CVS STORE NO. 07464
SWC HORIZON RD. & RIDGE RD. (F.M. 740)
ROCKWALL, TEXAS

AS-BUILT
Winkelmann & Associates, Inc. hereby states that this plan, to the best of our knowledge is "As Built." Modifications from the originally approved construction documents have been made as per information provided by the contractor. Winkelmann & Associates, Inc. does not certify as to the correctness or quality of construction as no field inspection was performed.
Michael T. Doggett
WINKELMANN & ASSOCIATES, INC. 07-16-15 DATE

03/27/2015 CHANGE ORDER NO. 1
09/29/2014 ADDENDUM NO. 2
06/12/2014 ADDENDUM NO. 1
07/28/2014 RE-DESIGN

STORE NUMBER: 07464
SWC HORIZON RD. AND RIDGE RD.
ROCKWALL, TEXAS
PROJECT TYPE: EXTERIOR REMODEL
DEAL TYPE: FEE FOR SERVICE
CS PROJECT NUMBER: 76657

DRIVEWAY
XSECT 1

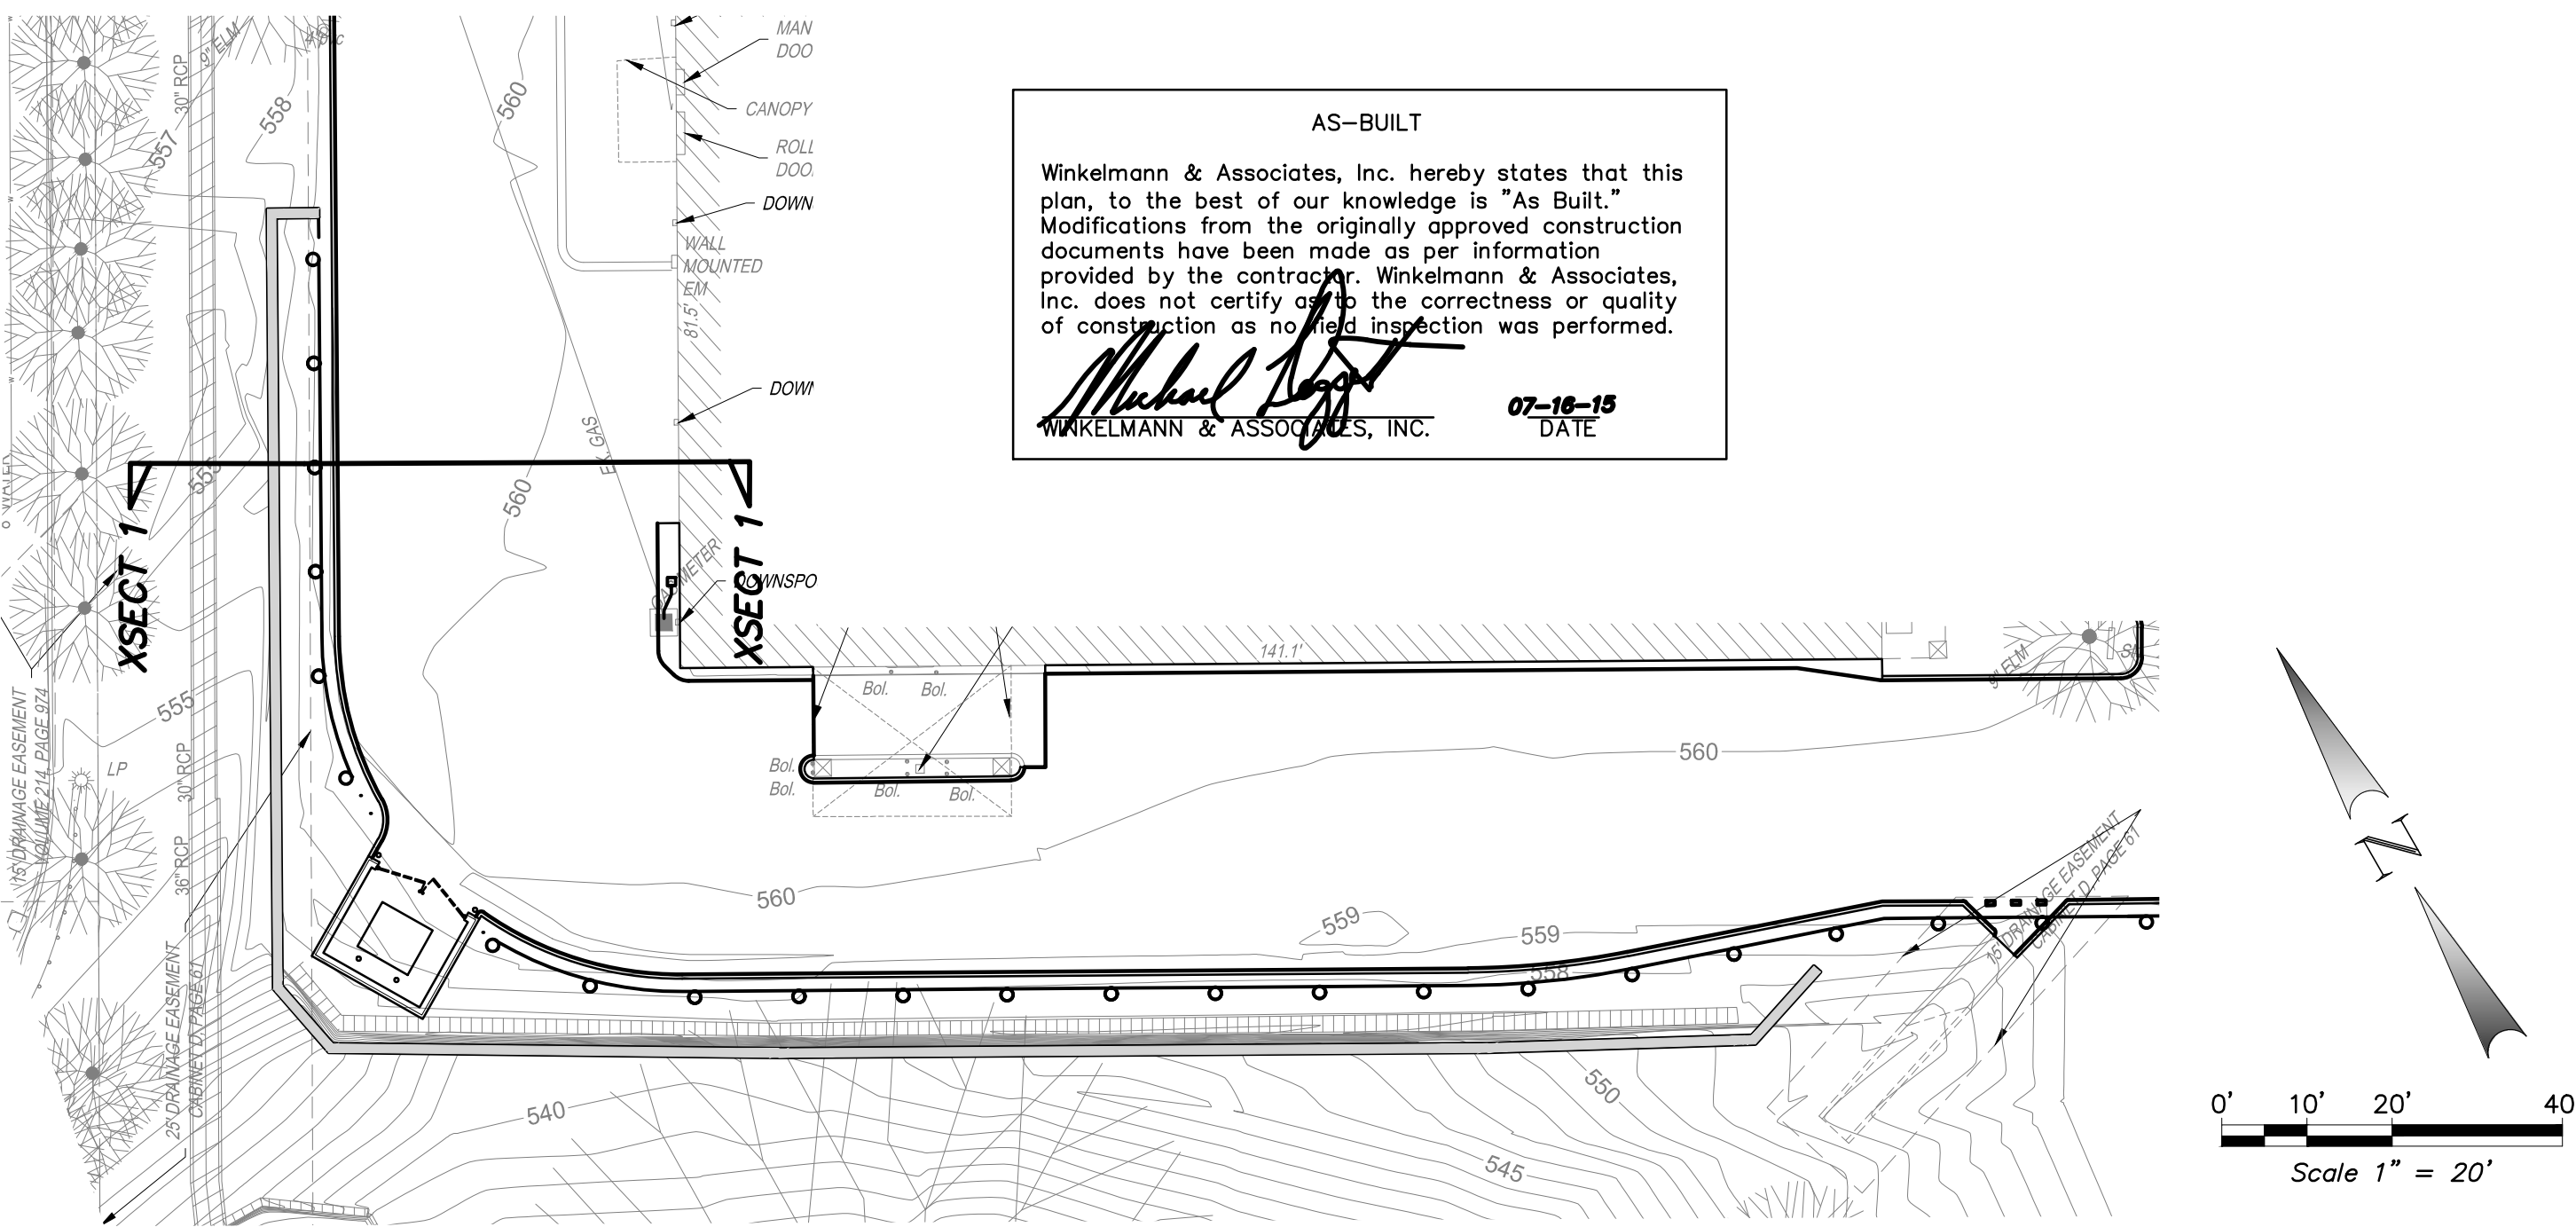
C.O. #1 HAND RAIL ANCHOR BOLTS TO BE LENGTHENED TO ACCOUNT FOR BRICK CAP/MORTAR THICKNESS AND PROVIDE MIN. 5" DEPTH INTO CONCRETE WALL PER TxDOT PRD-13 DETAILS ~ ANCHORING METHOD TO BE REVIEWED AND APPROVED BY OWNER'S ENGINEER AND A STRUCTURAL ENGINEER REGISTERED IN THE STATE OF TEXAS PRIOR TO MANUFACTURE AND INSTALLATION. AN ALTERNATE METHOD OF POLE ACHORAGE MAY BE PROPOSED, BUT STILL MUST BE APPROVE AS DESCRIBED ABOVE.

C.O. #1 ALL PORTIONS OF TxDOT PRD-13 TYPE "E" HANDRAIL SHALL BE PAINTED AS DESCRIBED ON PRD-13 SHEET 3 OF 3 USING TxDOT ITEM NO. 446 "CLEANING AND PAINTING STEEL". COLOR OF PAINT SHALL BE SPECIFIED BY OWNER PRIOR TO PAINTING.

C.O. #1 WALL CAP TO BE FULLY MORTARED BRICK MASONRY ROWLOCK HEADER CAP OF UNIFORM WIDTH ALONG ENTIRE LENGTH OF WALL. CAP TO MATCH WALL VENEER.

SHEET NUMBER:
C-10

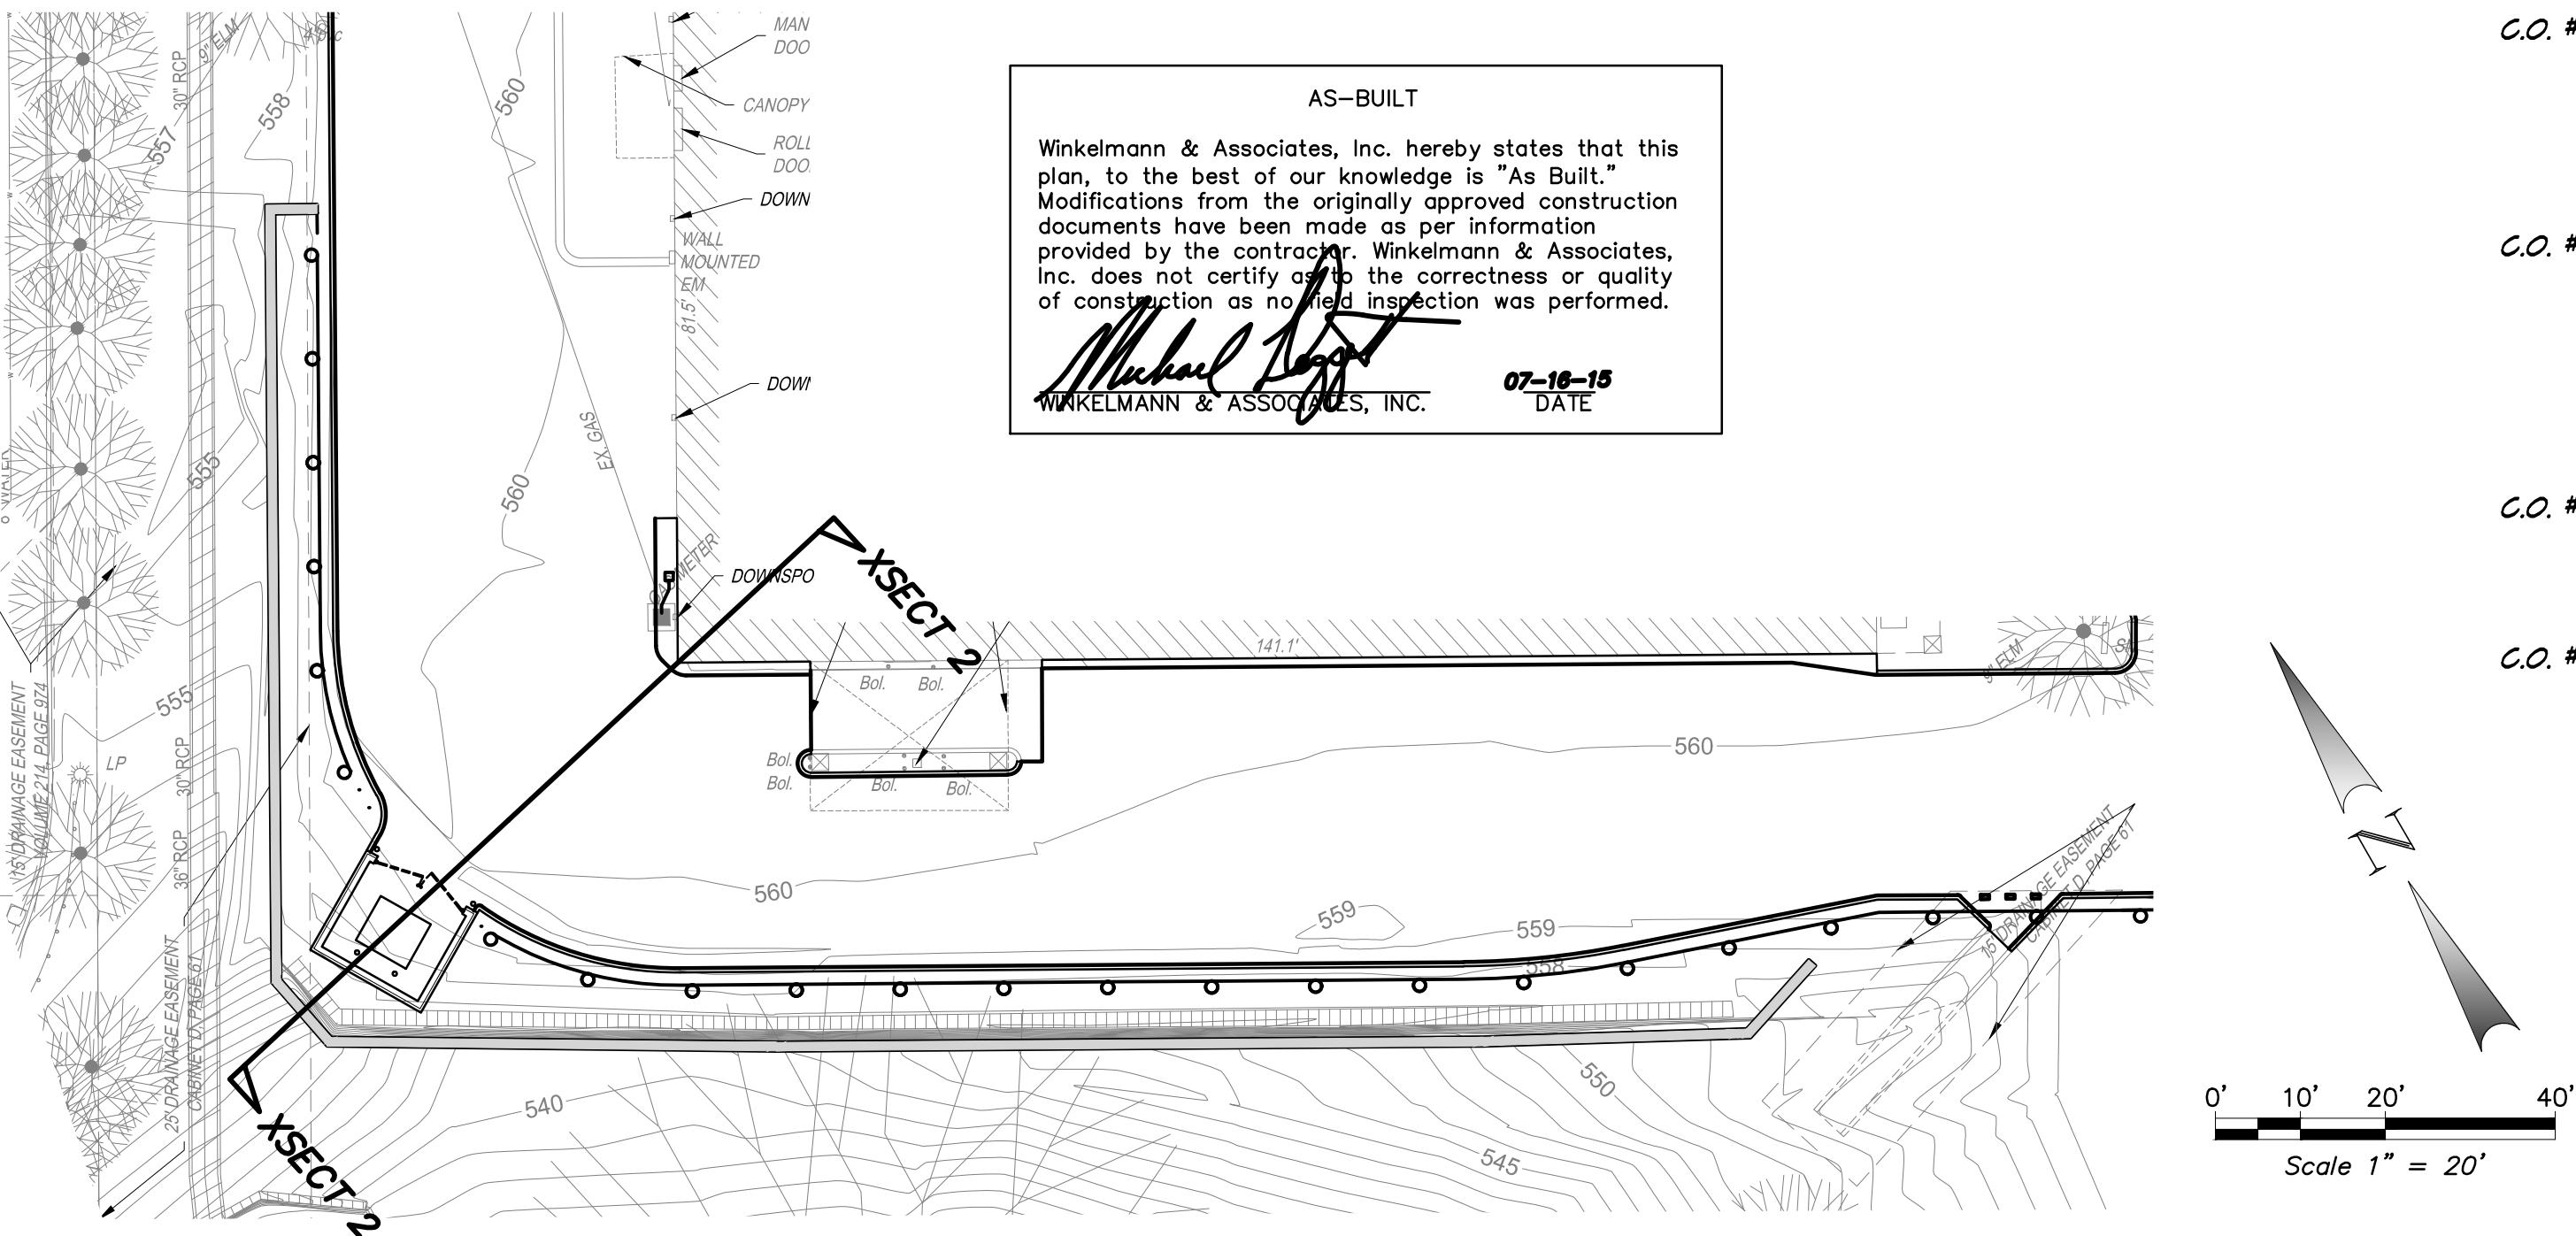
C.O. #1 ALL EXPOSED/EXTERIOR FACES/ENDS OF SHOTCRETE WALL TO BE BRICK VENEER TO MATCH BUILDING. BRICK TO BE INSTALLED PER HAYWARD-BAKER DESIGN/DIRECTION.

C.O. #1 HAND RAIL ANCHOR BOLTS TO BE LENGTHENED TO ACCOUNT FOR BRICK CAP/MORTAR THICKNESS AND PROVIDE MIN. 5" DEPTH INTO CONCRETE WALL PER TxDOT PRD-13 DETAILS ~ ANCHORING METHOD TO BE REVIEWED AND APPROVED BY OWNER'S ENGINEER AND A STRUCTURAL ENGINEER REGISTERED IN THE STATE OF TEXAS PRIOR TO MANUFACTURE AND INSTALLATION. AN ALTERNATE METHOD OF POLE ACHORAGE MAY BE PROPOSED, BUT STILL MUST BE APPROVE AS DESCRIBED ABOVE.

C.O. #1 ALL PORTIONS OF TxDOT PRD-13 TYPE "E" HANDRAIL SHALL BE PAINTED AS DESCRIBED ON PRD-13 SHEET 3 OF 3 USING TxDOT ITEM NO. 446 "CLEANING AND PAINTING STEEL". COLOR OF PAINT SHALL BE SPECIFIED BY OWNER PRIOR TO PAINTING.

NAME: 70801-Grd.dwg
 NUMBER: 70801.00
 DATE: JULY 28, 2014
 DRAWN BY:
 DRIVEWAY
 XSECT 3
 DET NUMBER:
 C-11

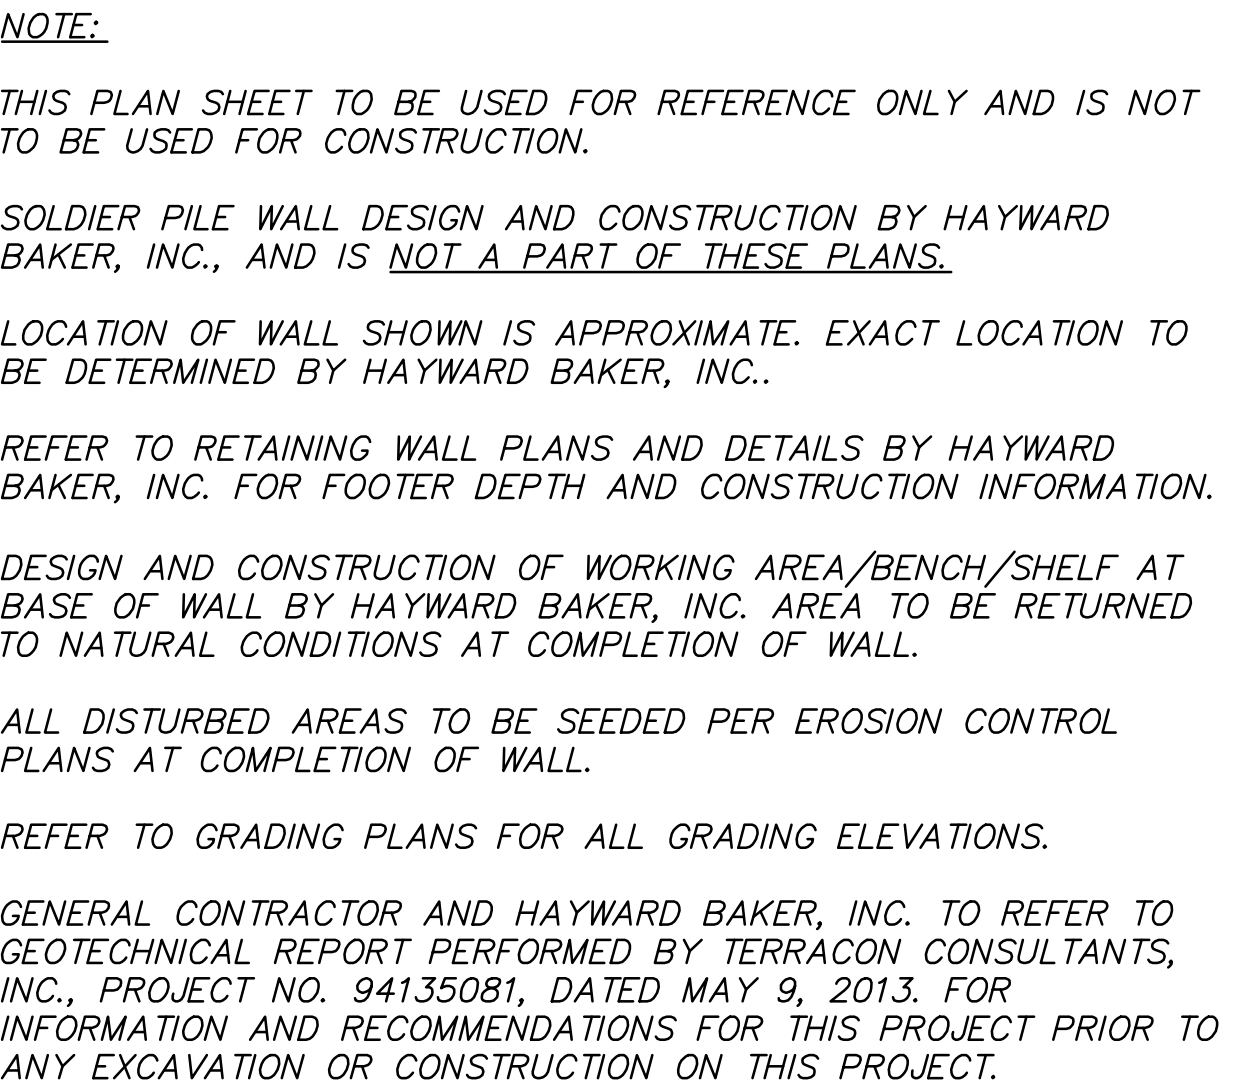
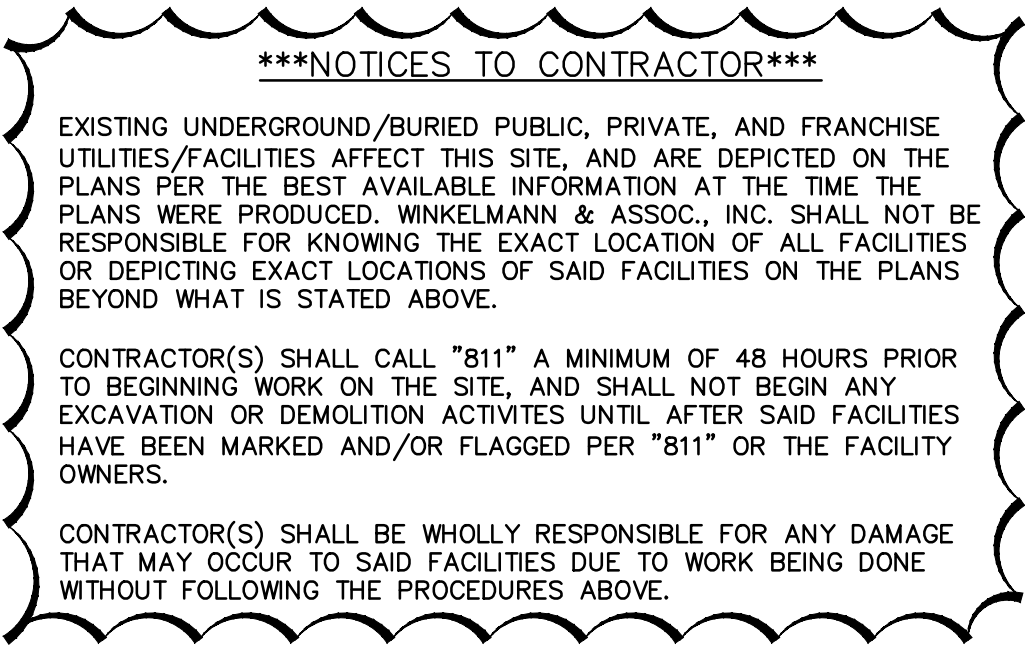
HAND RAIL ANCHOR BOLTS TO BE LENGTHENED TO ACCOUNT FOR
 BRICK CAP/MORTAR THICKNESS AND PROVIDE MIN. 5" DEPTH INTO
 CONCRETE WALL PER TxDOT PRD-13 DETAILS ~ ANCHORING METHOD
 G.O. #1 TO BE REVIEWED AND APPROVED BY OWNER'S ENGINEER AND A
 STRUCTURAL ENGINEER REGISTERED IN THE STATE OF TEXAS PRIOR
 TO MANUFACTURE AND INSTALLATION. AN ALTERNATE METHOD OF
 POLE ACHORAGE MAY BE PROPOSED, BUT STILL MUST BE APPROVE
 AS DESCRIBED ABOVE.

C.O. #1 WALL CAP TO BE FULLY MORTARED BRICK MASONRY ROWLOCK
HEADER CAP OF UNIFORM WIDTH ALONG ENTIRE LENGTH OF WALL.
CAP TO MATCH WALL VENEER.
